SAN FRANCISCO BAY CONSERVATION
& DEVELOPMENT COMMISSION

Subject: **Temporary Fence for Phase 3, Westpoint Harbor**

Reference: Your March 23, 2017, Letter Regarding Amendment 7 (2002.002.07)

SITE PLAN WITH TEMPORARY PHASE 3 SAFETY FENCE
WESTPOINT HARBOR
REDWOOD CITY, CA

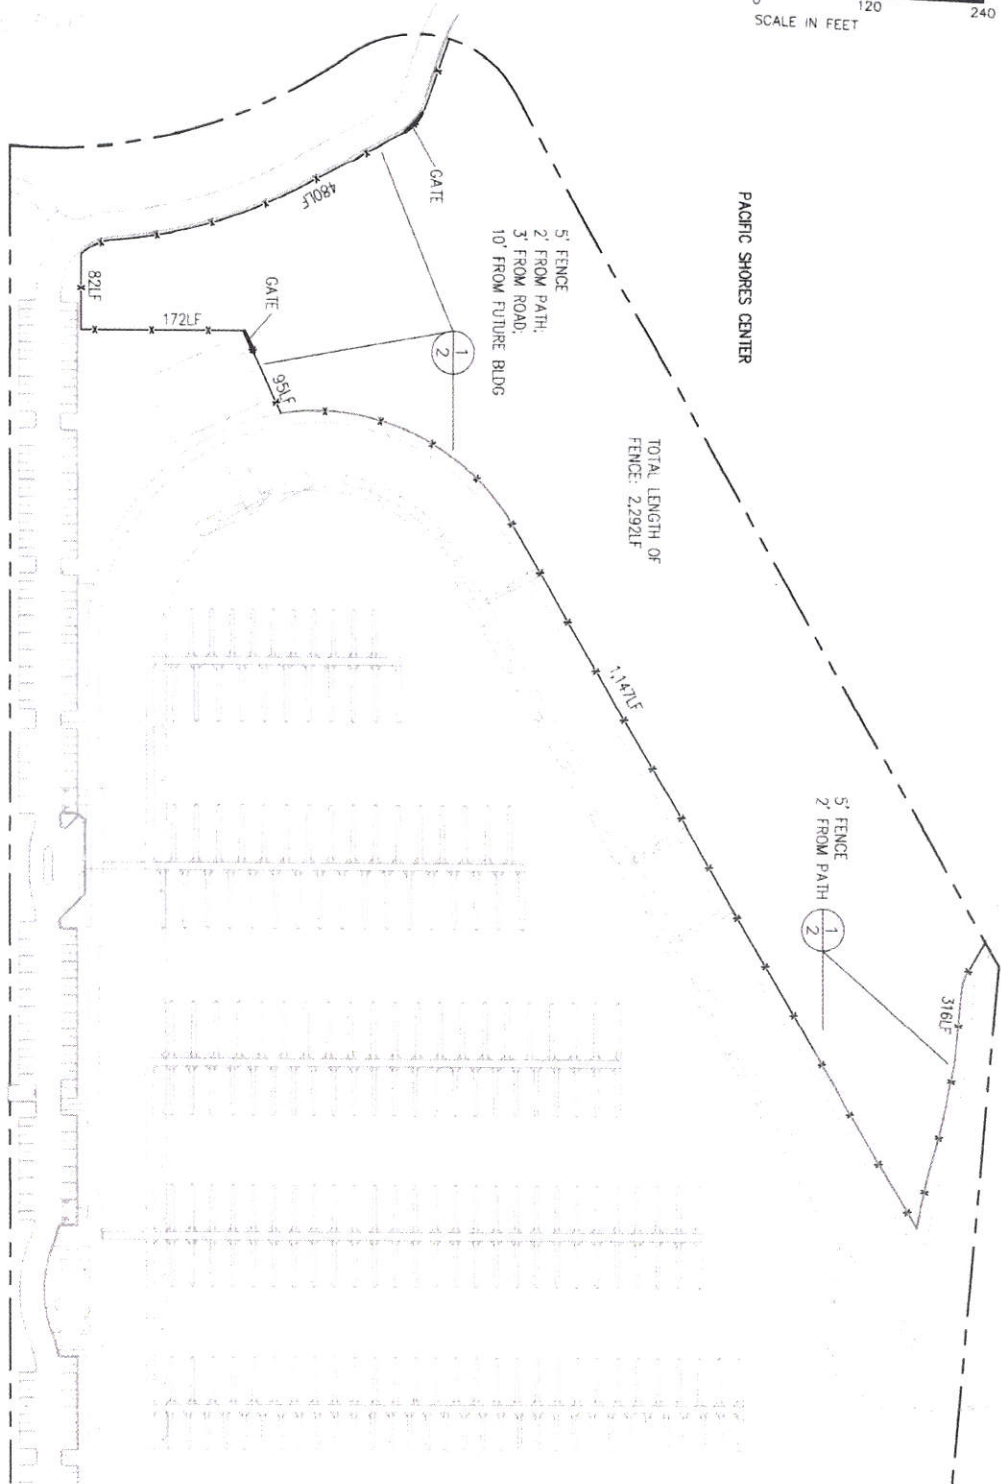
1. Full-size and reduced-size plans of the Phase 3 area to be temporarily fenced are attached. The civil engineer added the overall fence length, lengths of sections, setback from the Bay Trail, and description and height of the fence. The location of two gates for construction and emergency vehicles is also shown. The fence color is silver and "T-post driver" is the method of installation, directly into the ground as shown on the page 2 drawing.

2. We recognize your request for a 4' setback from the path: however as previously discussed and agreed with BCDC staff the fence setback is 2' for a several existing infrastructure reasons. Power, potable/fire water and communications are located under the path, and irrigation waterlines, valves, Christie boxes and control wiring are outside the path approximately 3'. Similarly, streetlight conduits and connection boxes are also outside the path approximately 4'. The 2' setback gives adequate separation between the path and undeveloped phase 3 without impinging on utilities and allows servicing. Moreover the SWPPP swale is 4' from the path and hazardous when rainy (swale photo attached).

3. The fence does not interfere with the five view corridors shown on the public access drawings. The fence is located on the side of the path *away* from all Bay and marina views, and in the opposite direction is the future retail area, Pacific Shores Center (eight-story buildings), and Cemex concrete plant.

TEMPORARY FENCING

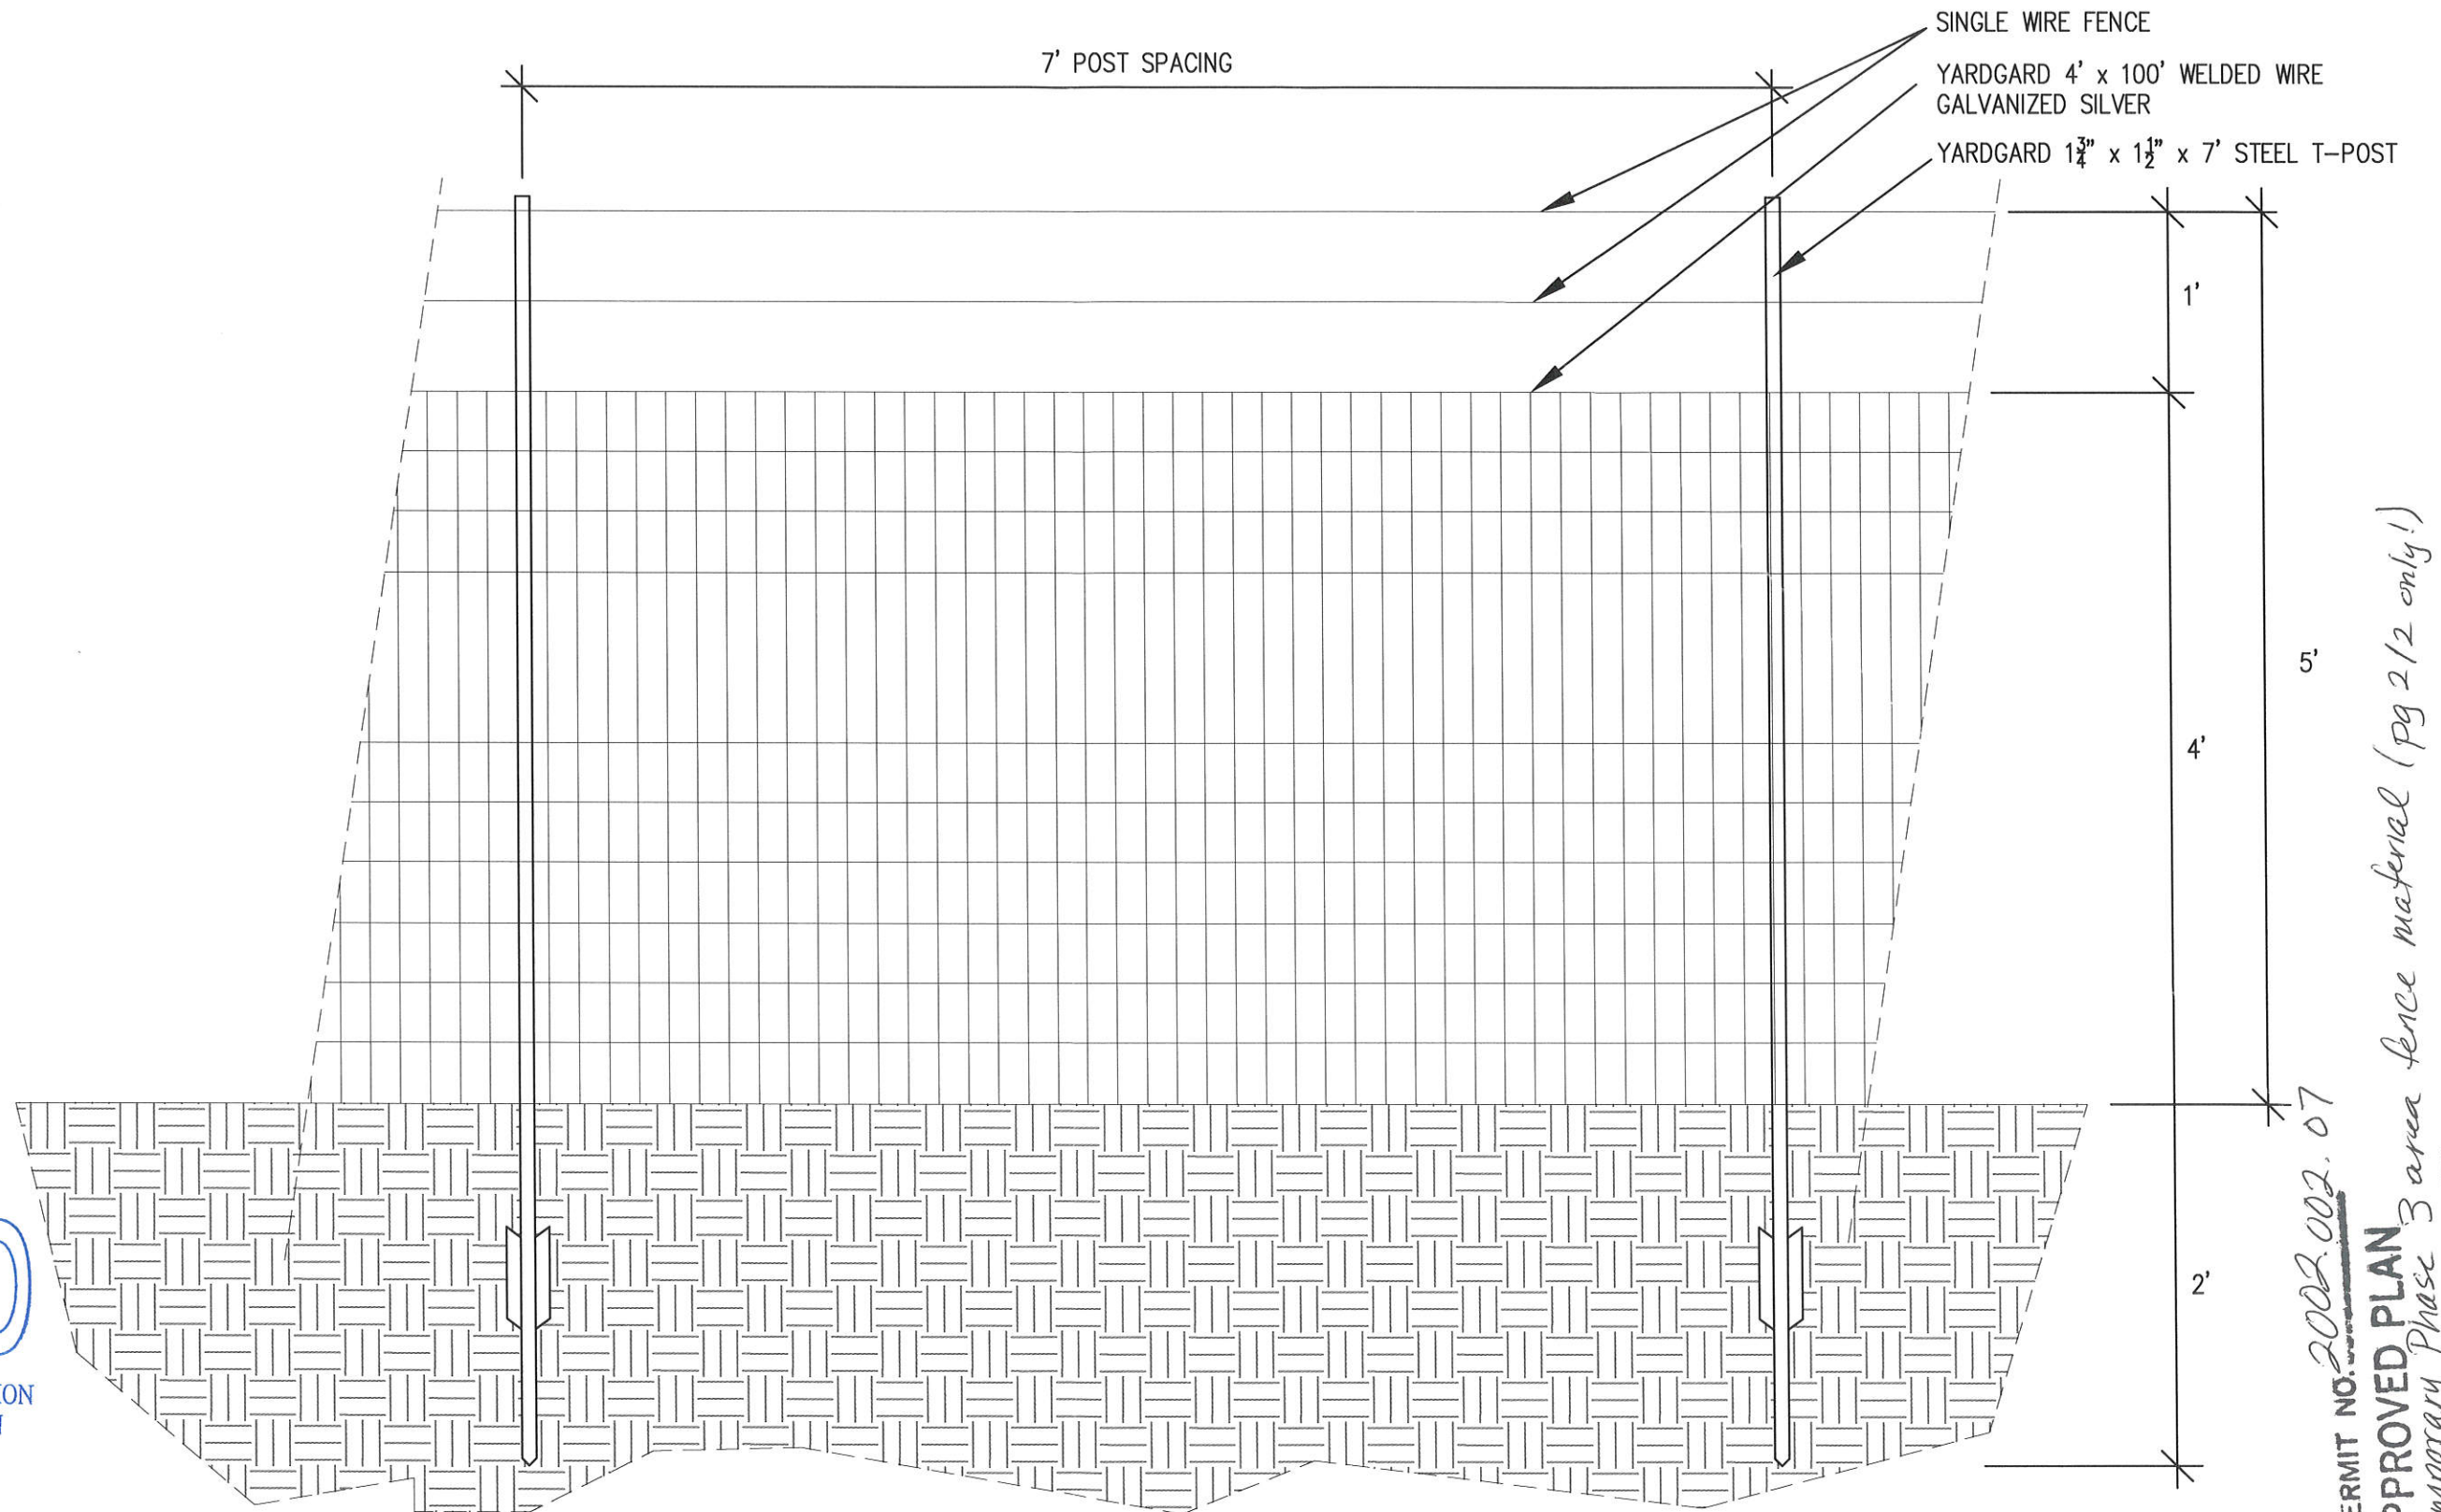
4. A shorter fence (e.g. 3' high) would be ineffective because people simply step over it to enter areas restricted for public safety. The previously approved 2"x3" welded-wire fence is 4' high plus two plain-wire strands for an overall height of 5'. This is the minimal necessary for safety and doesn't interfere with views or trap leaves. The 4' mesh prevents off-leash dogs from getting into the restricted area which might tempt people to climb the fence to retrieve them, and the two wire strands minimize visual impacts.

SDC PERMIT NO. 2002.002.07
APPROVED PLAN
Temporary Phase 3 area fence material (pg 2/2 only!)
